**SUBJECT: TRANSMITTAL OF CLASS 2 PERMIT MODIFICATION TO THE LOS
ALAMOS NATIONAL LABORATORY (LANL) HAZARDOUS WASTE
FACILITY PERMIT**

Subject: Request for Class 2 Permit Modification to the Los Alamos National Laboratory (LANL) Hazardous Waste Facility Permit for Technical Area 54, Building 38, West, EPA ID No. NM0890010515

**Class 2 Permit Modification Request for
Technical Area 54, Building 38 (TA-54-38) West
Los Alamos National Laboratory Hazardous Waste Facility Permit
January 2013**

Figure G.16-1: Technical Area 54, Building 38 (High, Low Bay, and Loading Dock Sampling Locations)

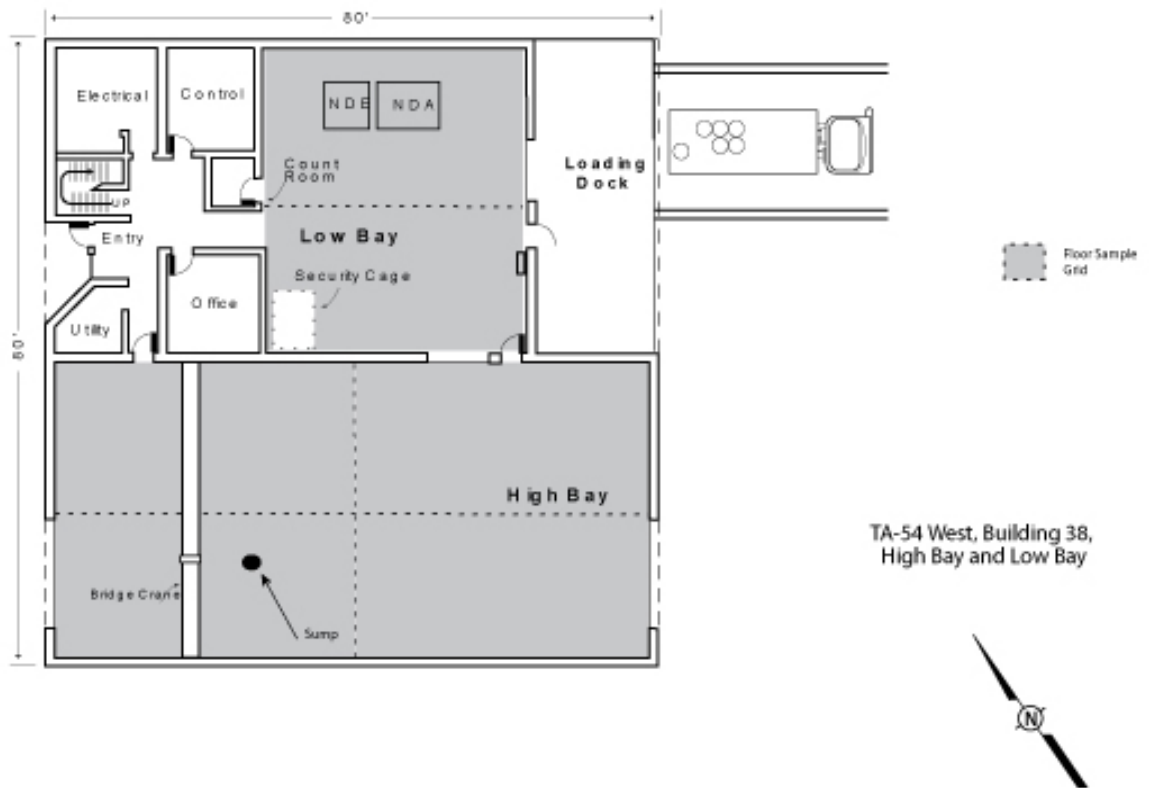
Attachment G.16, Figure G.16-1	Figure has been replaced.	Change has been made to illustrate the larger footprint of the entire High Bay and Low Bay as the permitted unit boundary, incorporate sample areas for the larger footprint, and remove the loading dock sample locations.
Attachment G.17, Section 6.1, Last paragraph	Sample locations for the loading dock have been added.	Change has been made to correct the location of the loading dock sampling requirements within the closure plans.
Attachment G.17, Figure G.17-1	Figure has been replaced.	Change has been made to correct the location of the loading dock sample areas within the closure plans. The figure was also changed to remove a structure (357) that does not exist at the unit and is not included within either Figures 9 or 37 in Attachment N.
Attachment J, TA-54, West Indoor	Operating capacity has been increased.	Change has been made to increase the operating capacity of the unit to allow the flexibility of managing shipments of larger containers.

- a. ~~four~~ nine wipe samples from the High Bay (*see* Figure G.16-1):
1. ~~two~~four from the floor;
 2. one from ~~the~~each wall; and
 3. one from the sump;
- b. ~~one~~six wipe samples s from the Low Bay (*see* Figure G.16-1):
1. two from the floor; and
 2. one from each wall.
- c. ~~one from the floor; and~~
- d. ~~two wipe samples from the Loading Dock areas identified as 'sample area 1' and 'sample area 2' (*see* Figure G.16-1)~~

Figure G.17-1: Technical Area 54 West Outdoor Container Storage Unit Grid Sampling and Additional Sampling Locations

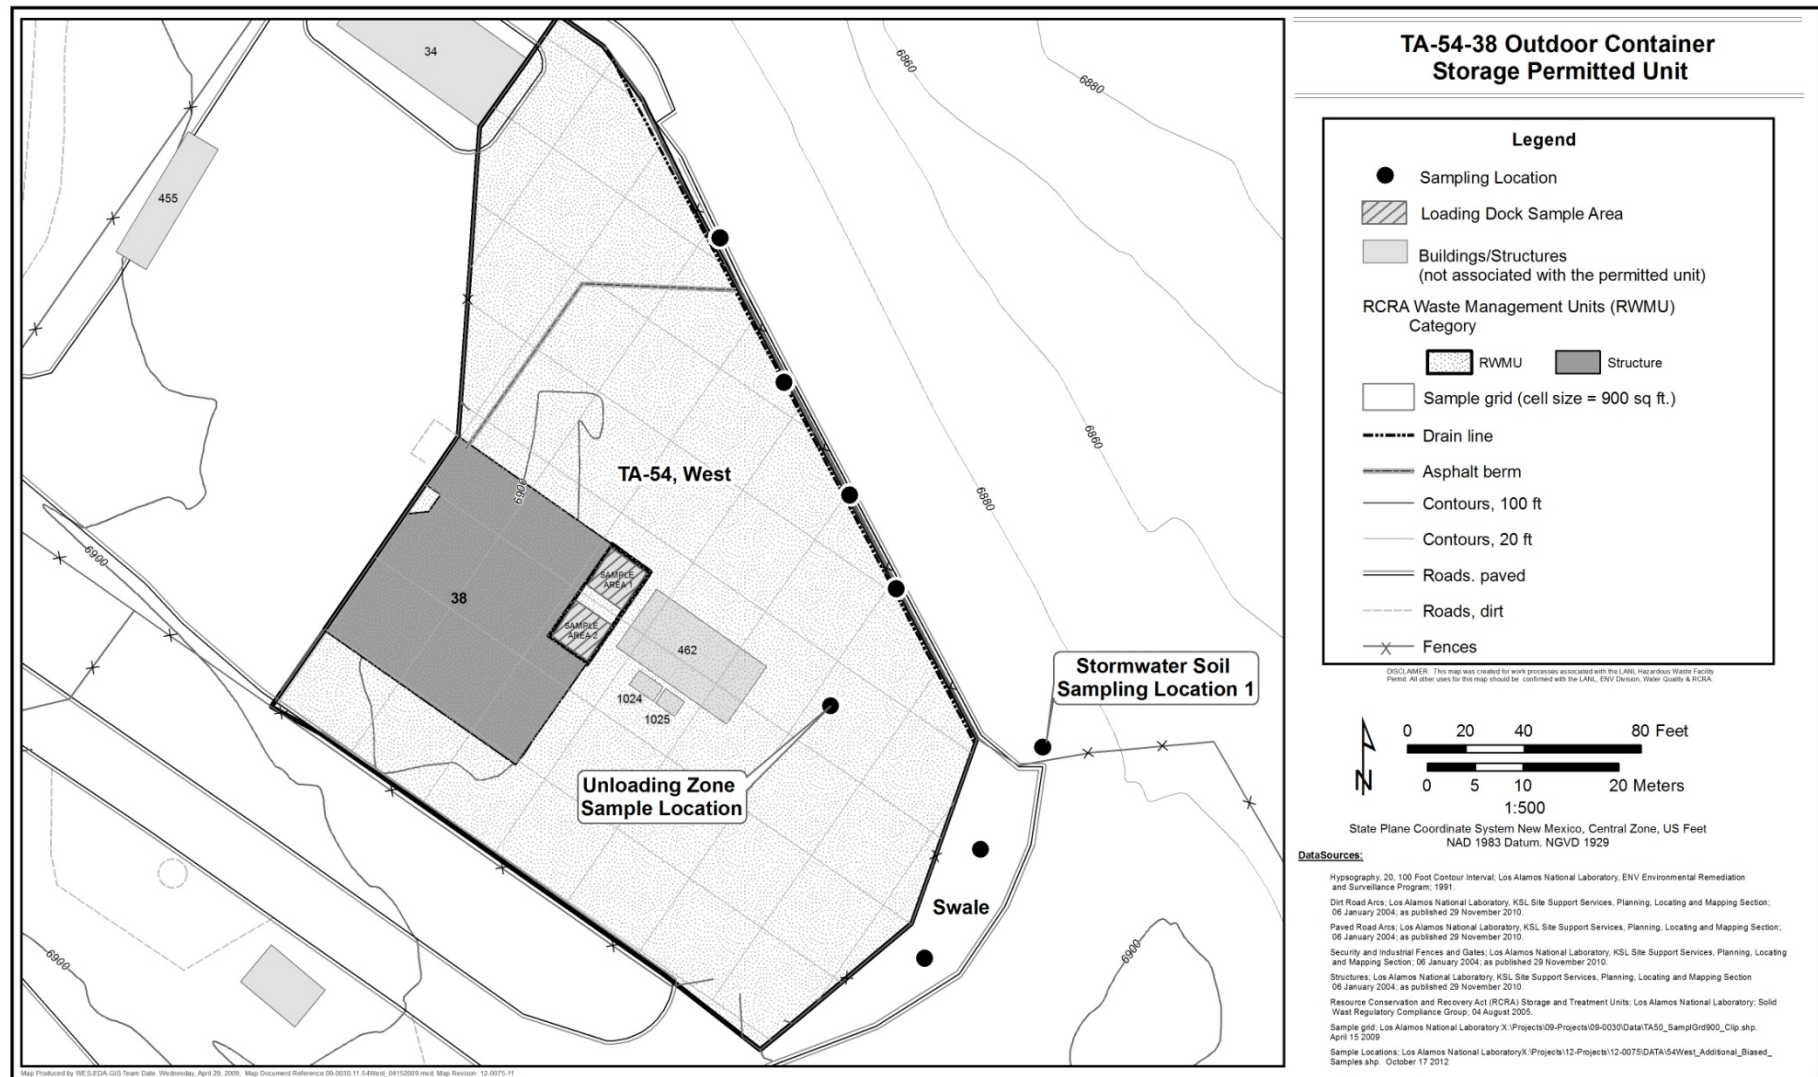
Permit Attachment G.17, *Technical Area 54 West, Outdoor Container Storage Unit Closure Plan*, has been revised in Sections 6.1 and on Figure G.17-1 to add references to the loading dock. Section 2.0 of the closure plan already includes an accurate description of the loading dock; therefore, no changes were made to that section of the closure plan. Section 6.1 has been revised to include the sample locations for the loading dock that were previously included in Permit Attachment G.16. The sample areas have also been added to Figure G.17-1.

An additional two wipe samples are required from the Loading Dock areas identified as 'Sample Area 1' and 'Sample Area 2.' Figure G.17-1 illustrates the sampling locations discussed in this section.

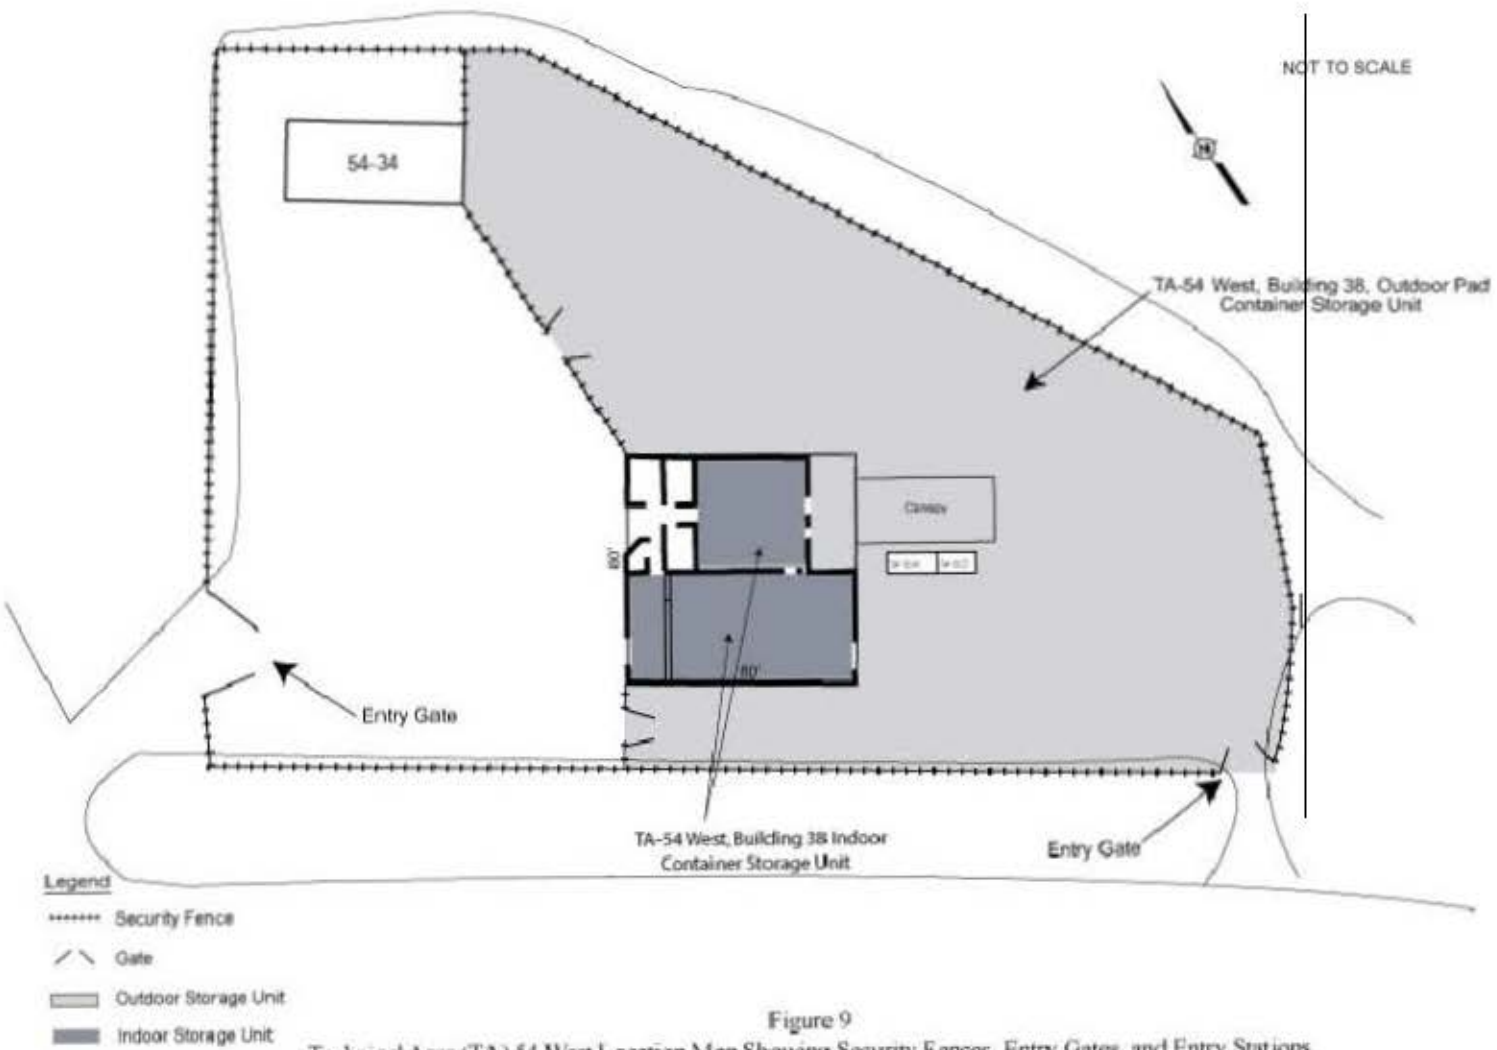
Figures 9 and 37 within Permit Attachment N, *Figures* have been updated to include the entire High Bay and Low Bay as part of the TA-54-38 West Indoor Unit.
